**NUMBER:** 23-014-14

**THIS BULLETIN SUPERSEDES SERVICE BULLETIN 23-012-12 REV. A, DATED October 04, 2012, WHICH SHOULD BE REMOVED FROM YOUR FILES. ALL REVISIONS ARE HIGHLIGHTED WITH **\*\*ASTERISKS\*\*** AND INCLUDE EXTENSION OF AFFECTED VEHICLE APPLICABILITY DATE PLUS ALTERNATIVE REPAIR PROCESS STEPS DEPENDENT ON VEHICLE BUILD DATE.**

Sliding Door Trim Contacting Vehicle Rear Quarter

**\*\*This bulletin depending on production date, involves either installing or engaging an additional door panel retention point to prevent the door panel from bowing and contacting the body when the sliding door is opened.\*\***

**Fig. 1 Door Trim Contact**

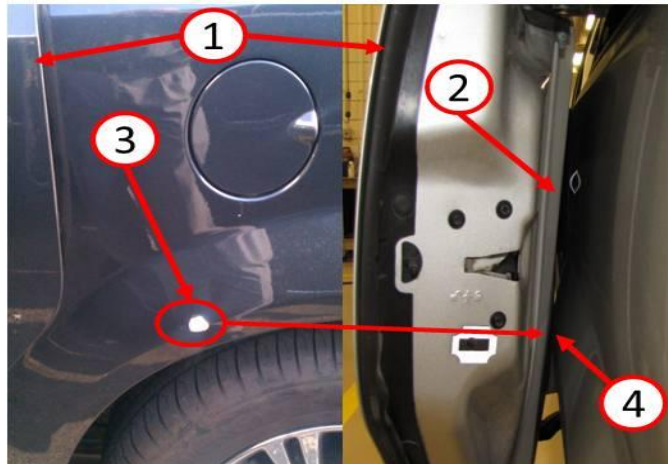
In some instances interior door panel to quarter panel contact has been noted on both left and right sides of the vehicle. Design clearances of the interior door panel are aggravated by heat which causes the door panel to relax and bow, which may contact the rear quarter panel (Fig. 1).

\*\*In order to correct this condition and avoid costly paint repairs, depending on production date, an additional retention point needs to be either added or engaged to prevent the door panel bowing condition. If the customer describes the symptom, perform the Repair Procedure.\*\*

**Fig. 2 Standoff Removal**

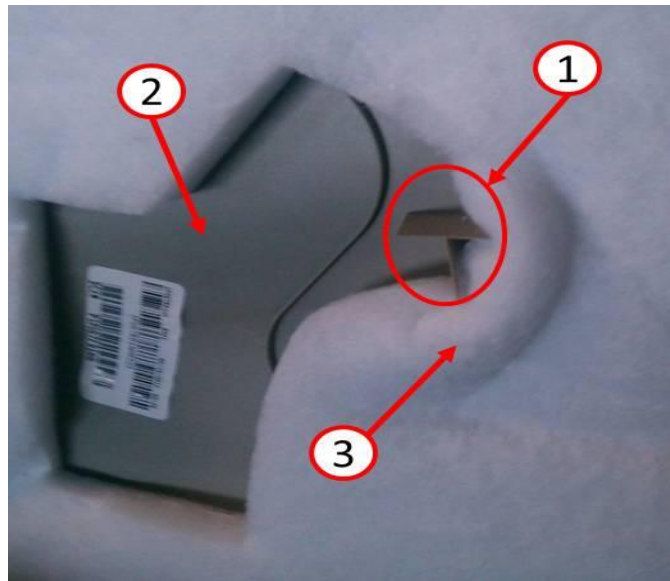
1. **\*\*Was the vehicle built on or before February 11, 2012 (MDH 0211XX)?**
  - a. YES>>> Vehicle was built on or before February 11, 2012. Continue with [Step #2](#).
  - b. NO>>> Vehicle was built on or after February 12, 2012 and on or before May 14, 2014. Proceed to [Step #12](#).\*\*
2. Remove both door trim panels. Refer to the detailed procedures available in DealerConnect>TechCONNECT> under: Service Info> 23-Body> Doors - Sliding> PANEL, Door Trim> Removal.
3. Remove the standoff from the back side of each door panel ([Fig. 2](#)).

**Fig. 3 Trim Sound Deadener**

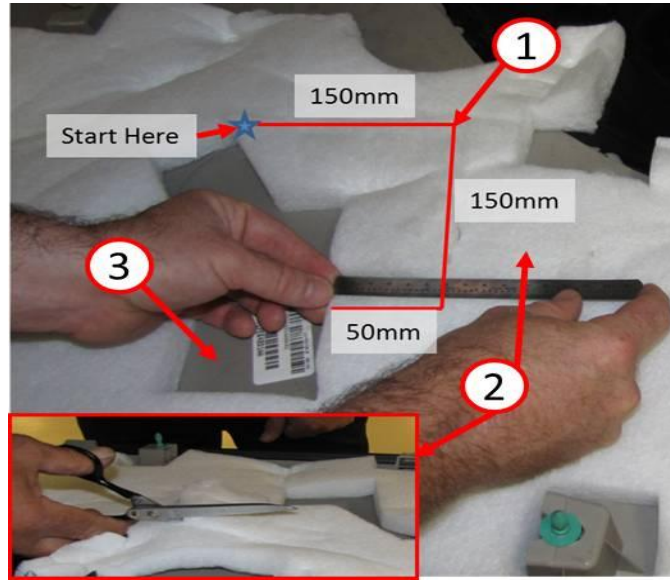
4. Cut the sound deadener on the back side of each door panel as shown in (Fig. 3).

***Fig. 4 Door Module Preparation***

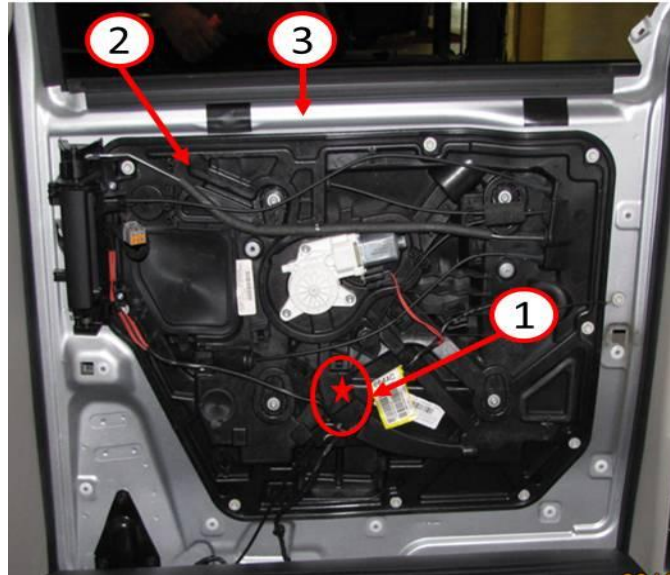
- Carefully drill a 5/16”(8mm) hole through door module at the center of the formation/standoff (1) directly above the door module (if equipped) or just forward of the part number tag (Fig. 4).

**NOTE: Make sure door window is in the full upward position before drilling hole in door module.**

***Fig. 5 Door Module Retainer Installation***

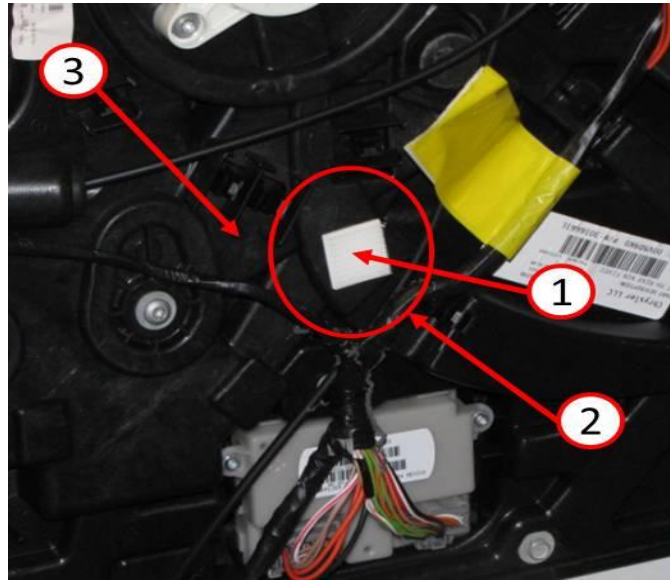
6. Fully seat the white dual lock push clips (1) from repair kit into the 5/16" (8mm) hole in the door modules ([Fig. 5](#)).

***Fig. 6 Door Panel Preparation***

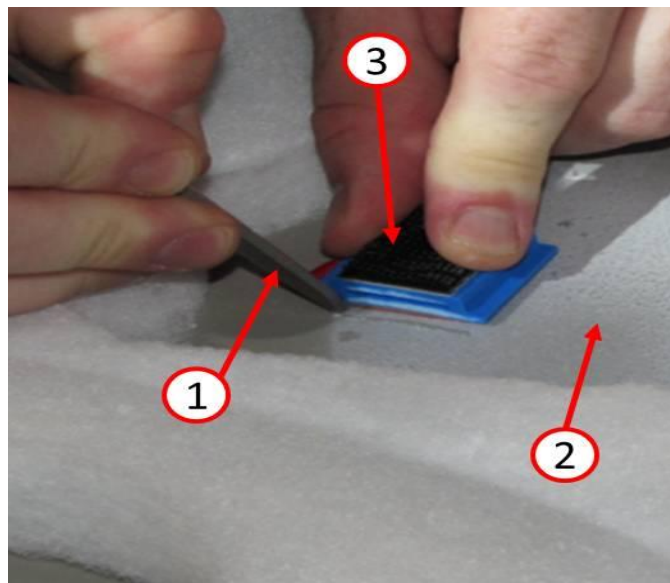
7. Temporarily engage the dual lock halves in order to transfer the clip location from the module to the door panel using Kent Leak Trace Powder or equivalent and scribe the clip location on the back side of the door panel as shown in (Fig. 6).

**NOTE: Door trim panel(s) will need to be rough set and pressurized to transfer the contact location. Leak trace powder should be applied to the approximate clip location on the back side of the door trim panel.**

**NOTE: Do not engage dual lock halves and remove peel-off backing to locate the door trim panel side of the clip as this could result in an improperly placed clip while reinstalling the door panel. Improperly placing the clip can possibly destroy it if removal or repositioning is required. Do not use grease to transfer clip location as this will leach into the plastic surface of the trim panel and affect clip adhesive retention.**

**Fig. 7 Door Panel Preparation**

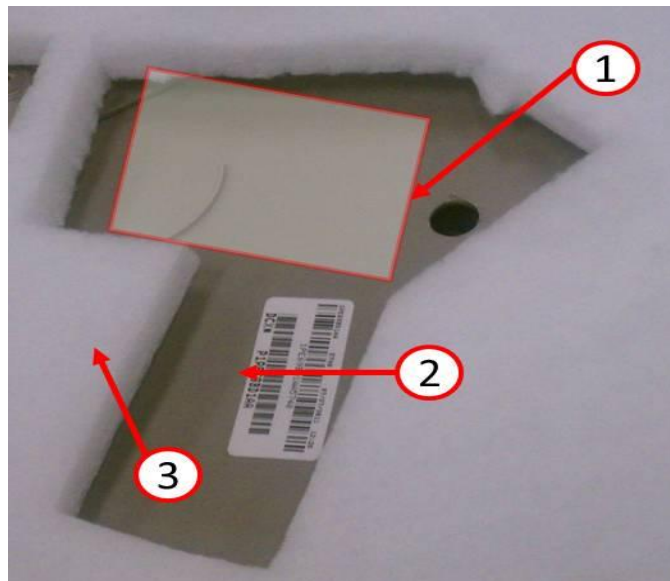
8. Clean the surface area (1) of both door trim panels to be bonded with isopropyl alcohol (Fig. 7).
9. Once the alcohol has evaporated apply 3M 4298 adhesion promoter or equivalent to the surface area (1) where the dual lock adhesive backer will bond (Fig. 7).

**Fig. 8 Door Panel Retainer Installation**

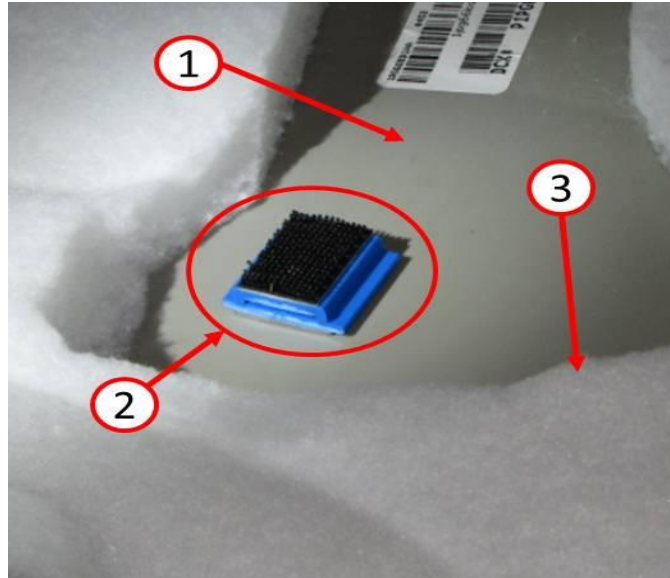
10. Firmly pressurize the blue dual lock clip at scribed location for 5 seconds after removing the protective backing off the adhesive side of the clip.

**NOTE: Let the blue dual lock clip cure for 1 hour before reinstalling the door trim panels.**

***Fig. 9 Dual Lock Engagement Location***

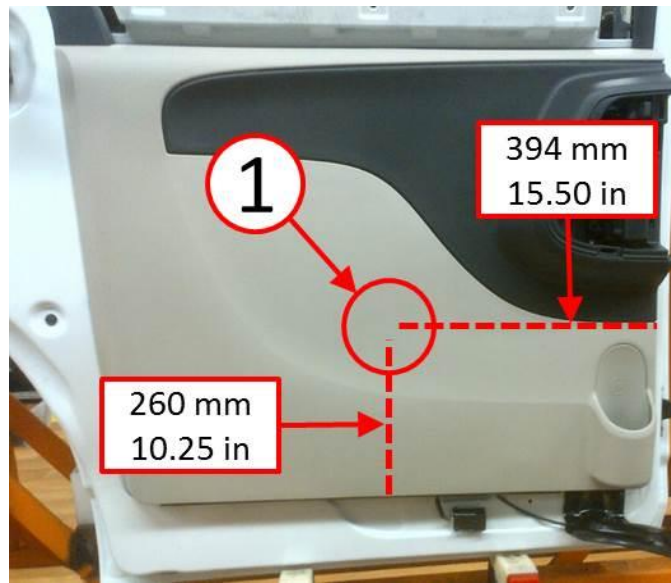
- 
11. Reinstall both door trim panels. Refer to the detailed procedures available in DealerConnect>TechCONNECT> under: Service Info> 23-Body> Doors - Sliding> PANEL, Door Trim> Installation.
  12. **\*\*Seat the door trim panel by pressing with firm pressure at the attachment location (1) a specified distance from bottom and leading edge of the door trim panel (Fig. 9).\*\***

**NOTE: An audible “click” should be heard when pressing the door trim panel in place.**

**Fig. 10 Improved Panel Clearance**

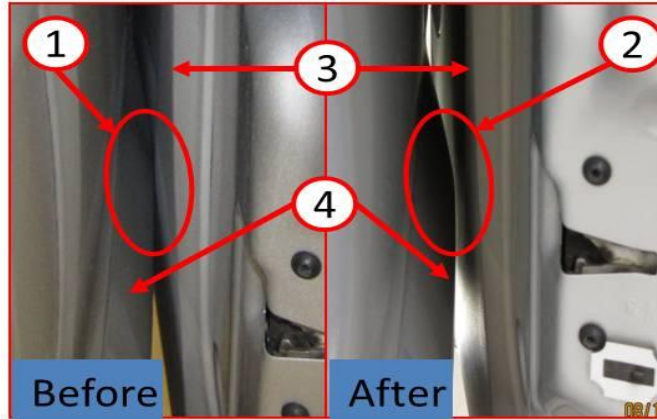
13. Validate door trim panel clearance to rear quarter panel (Minimum Gap is 3/16 in / 6 mm) (Fig. 10).

**NOTE: Gap can be checked by applying modeling clay to the suspect area of the quarter panel.**

14. **\*\*Was door trim panel clearance to rear quarter panel (Minimum Gap is 3/16 in / 6 mm) specified in Step #13 achieved?**

- a. YES>>> Repair is complete. Return the vehicle to the customer.
- b. NO>>> Remove one or both door trim panels that did not meet the clearance specification. Refer to the detailed procedures available in DealerConnect>TechCONNECT> under: Service Info> 23 - Body> Doors - Sliding> PANEL, Door Trim> Removal. Then inspect for any interference between the dual lock attachment point (3). Reposition and tape out of the way any cables (2) or labels (1) that may be interfering as shown in (Fig. 11). Then repeat Step #11 through Step #13.\*\*
